Sweatertech Ltd. (Extension 2)

22 April 2026

1. Building Information

2. Observation

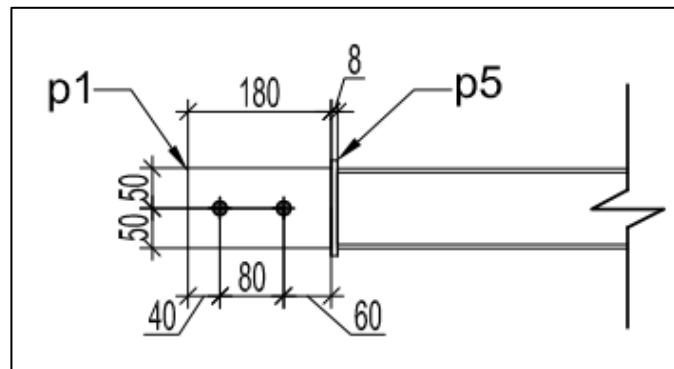
COLUMN TYPE#	Flange	
	bf	tf
SC-101~105,SC-111~120,SC-122~125	200	8
SC-107,110,114,115,115a	200	8
SC-108,109	200	8
SC-116,121,126	200	10

Flange thickness of steel columns were found 7.1 mm instead of 8 & 10 mm

The building engineer is required to survey the structure, update the as-built drawing as per onsite conditions, revise design report accordingly and submit updated design report to RSC.

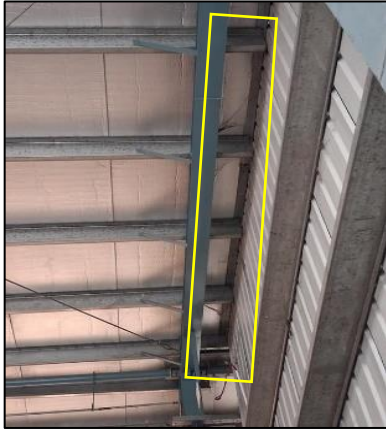
Side face joint found instead of bottom joint at grid I-5

One instead of two bolts in compression strut connection

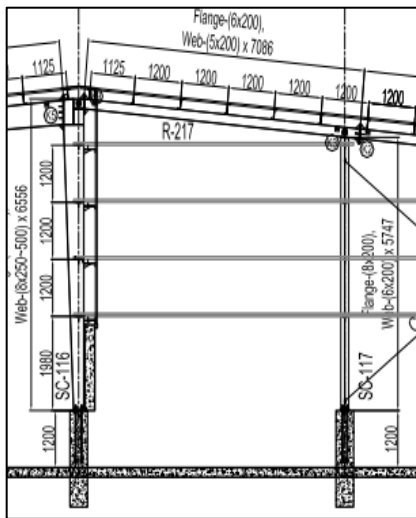
Flange brace missing at end grid

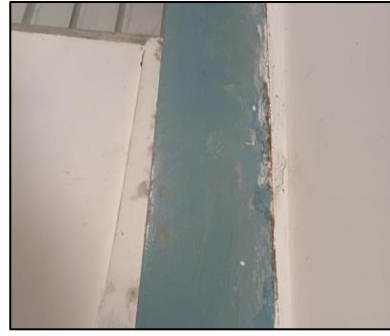
Flange brace missing adjacent to ridge

Wall girt missing at grid I

Description: During inspection several mismatches including mismatches in connection details & flange thickness of steel columns, missing in flange brace & wall girt were observed.
